**Submission to WestConnex M4 East Exhibition
Stage 1 – M4 (Parramatta to Haberfield)**

The purpose of this letter is to submit an objection in response to the WestConnex Exhibition, specifically Stage 1: Parramatta to Haberfield (M4 widening and M4 East).

Figure 1: Annual mean PM_{2.5} without the proposal (Source: WestConnex M4 East Air Quality Assessment Report, p. 160).

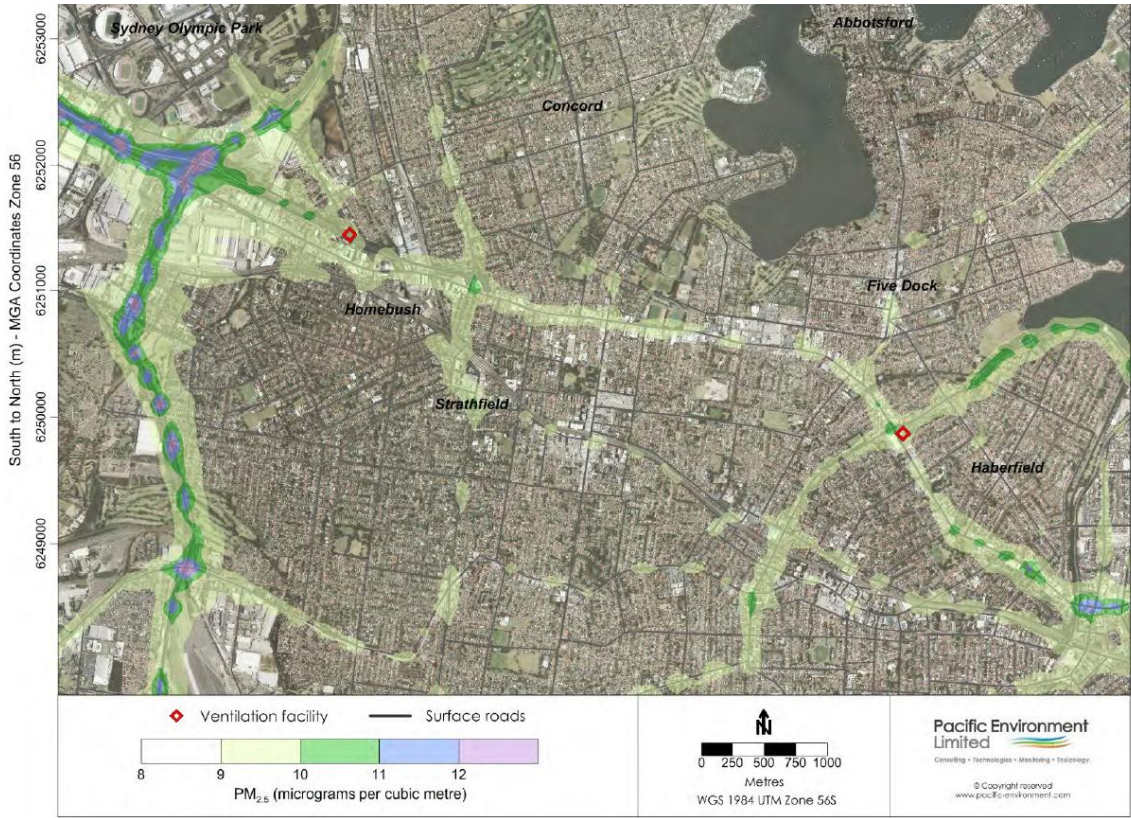
- Analysis within the EIS indicates how it is anticipated that there will be a build-up of air pollutants (such as PM_{2.5}) around the intersections and traffic lights along Wattle Street and Dobroyd Parade (see Figure 2). This has not been identified and addressed within the EIS.

Figure 3: Comparison of PM2.5 impacts in 2021 with and without the proposal.

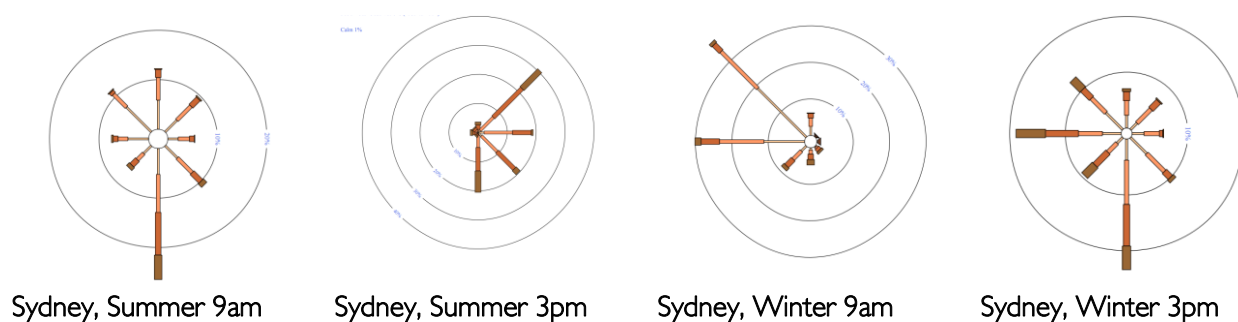
- Figure 3 shows that while weaker concentrations (9-10 micrograms per cubic metre) of PM_{2.5} are expected to decrease, stronger concentrations (10-11 micrograms per cubic metre) are expected to increase in certain areas along Wattle Street/Dobroyd Parade and the eastern section of Parramatta Road.
